# IWG-DPPS Comments

Deploy HEIGHT vs FULLY DEPLOYED

March 2018

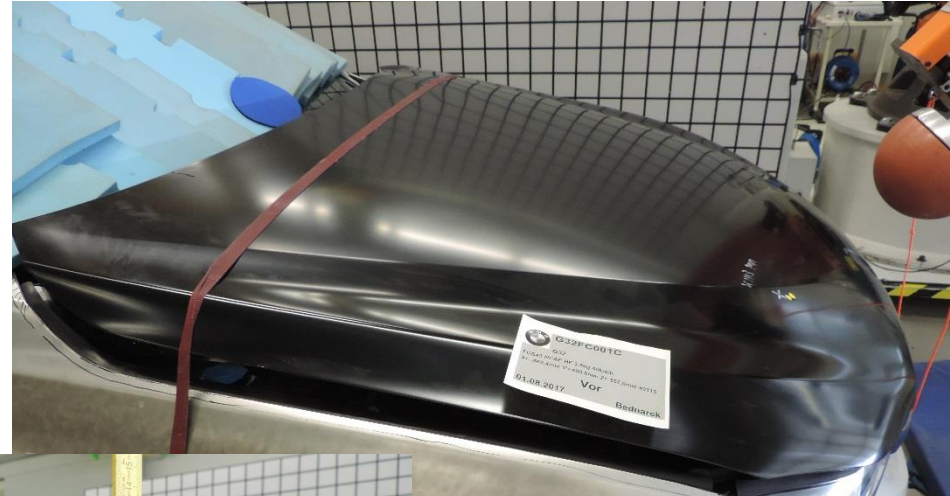
The system reaches and remains in the intended position before head impact;  
The system can be supported in a representative way <sup>2)</sup>

<sup>2)</sup> “Supported in a representative way” could mean e.g. by a spring system.

## FULLY DEPLOYED Height

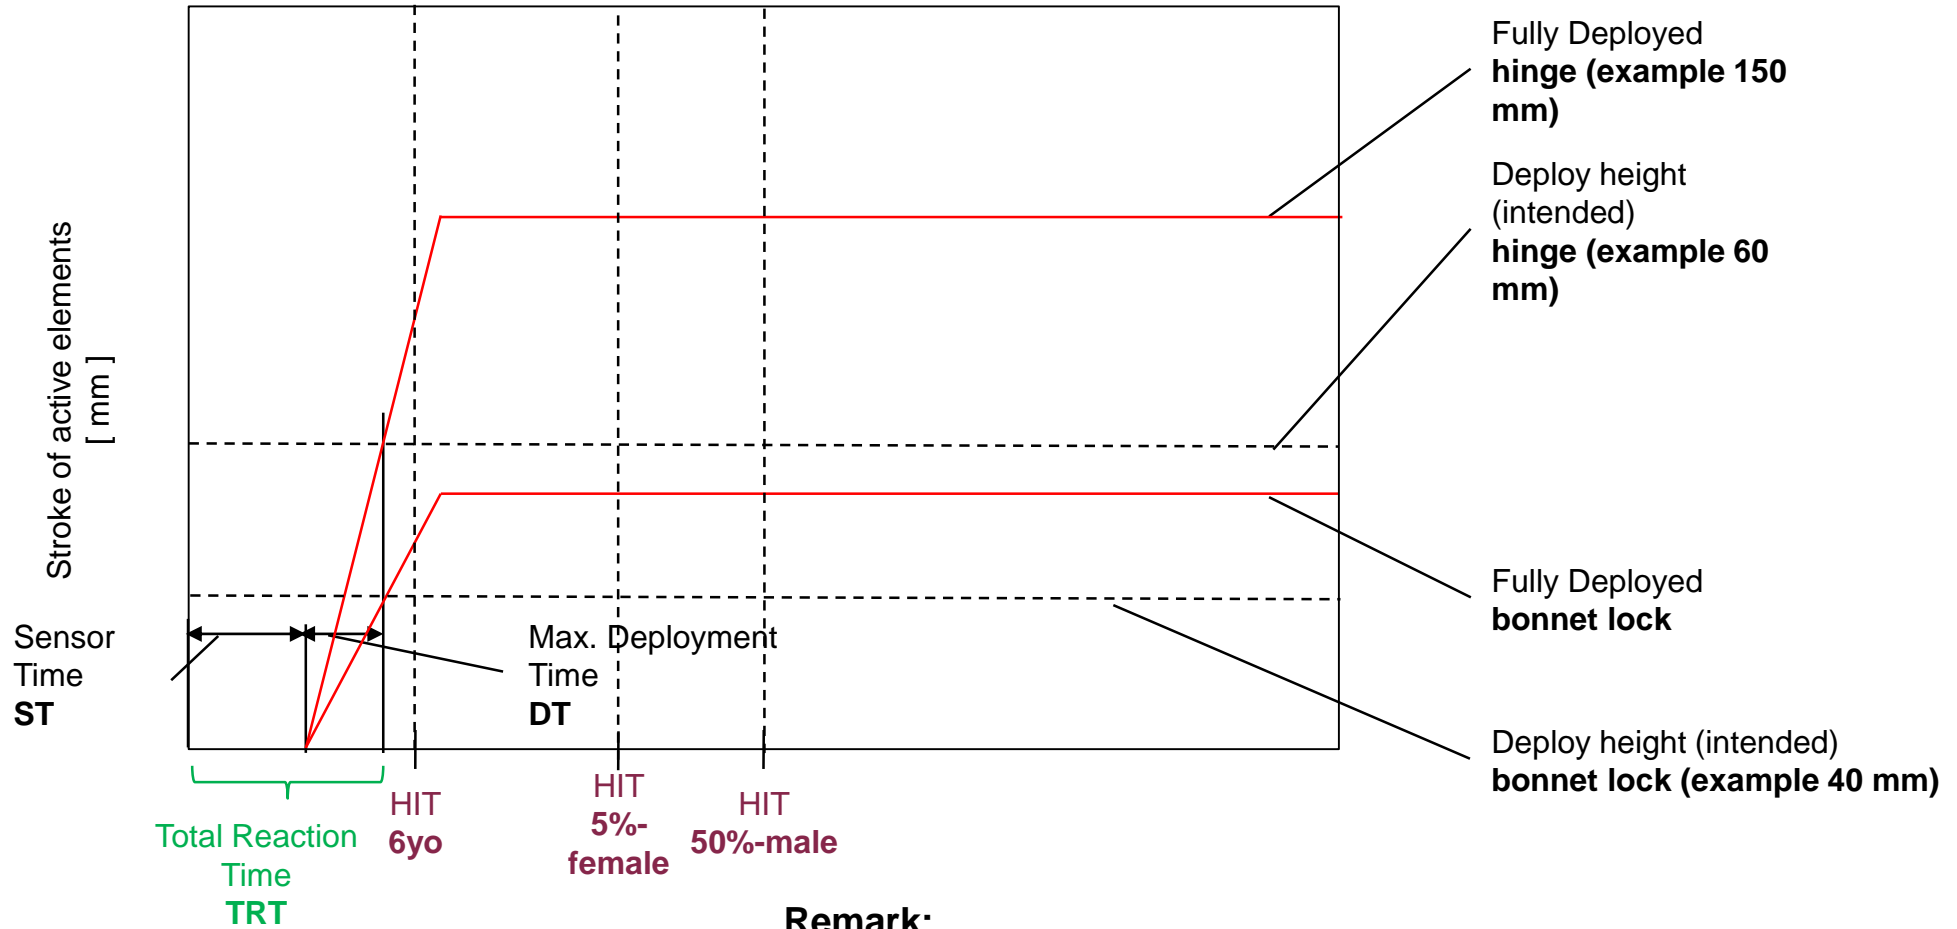
Fully Deployed  
Height  
150 mm

(to provide max.  
deformation space  
for larger  
pedestrians with  
later impacts)
